From: Joshua Hill
To: Danny Mapili - WPD-C
Cc: Terry Lamb Sr.; Todd Williams; Patrick J. Murray; Kaan Dilber; Andrea Mango; Edwin Lopacki - WPIB
Subject: RE: FERC Swing: Status of Design Review
Date: Friday, July 15, 2016 6:07:18 PM
Attachments: image001.png

Good morning Josh,
I would like to check the status of the Design Review for the 100%CD's FERC Swing.

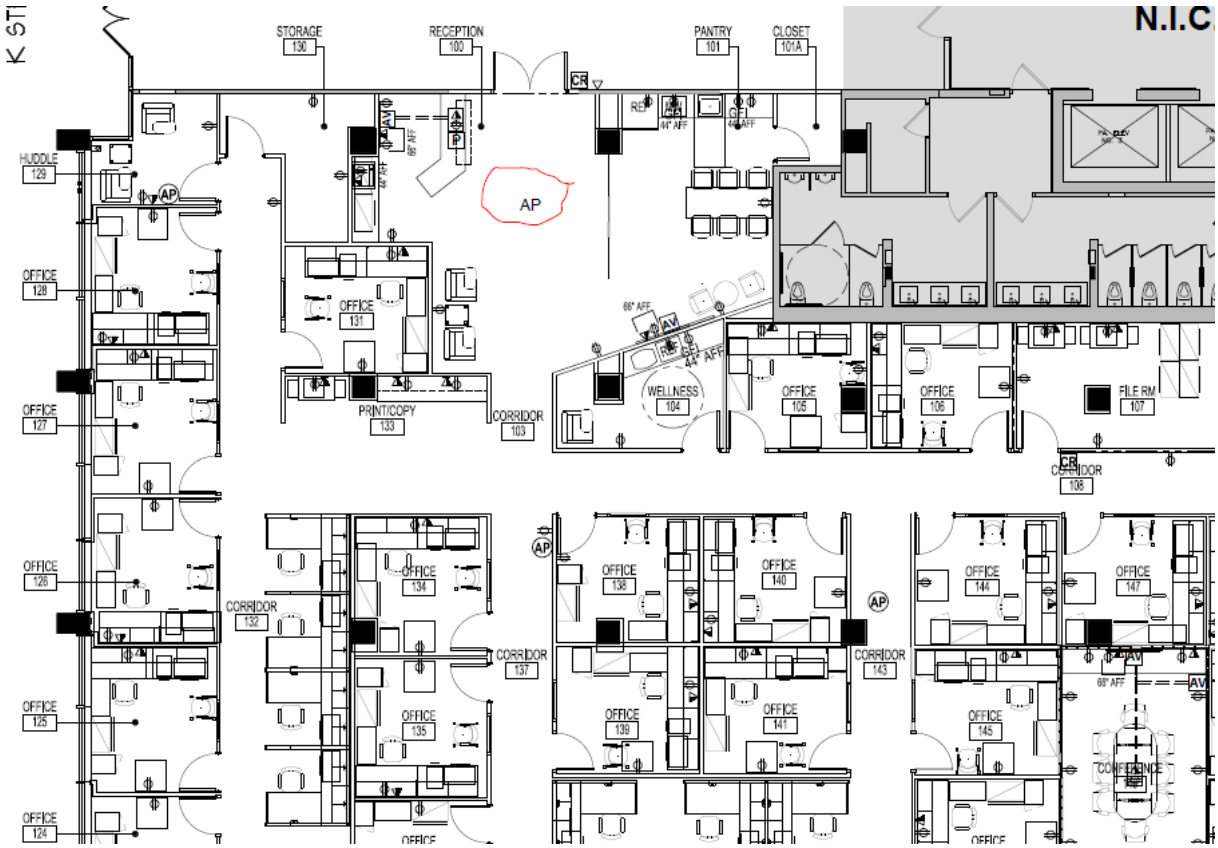
On A301, we may need an additional wireless access point located in the vicinity of the entrance to the suite (see drawing below).
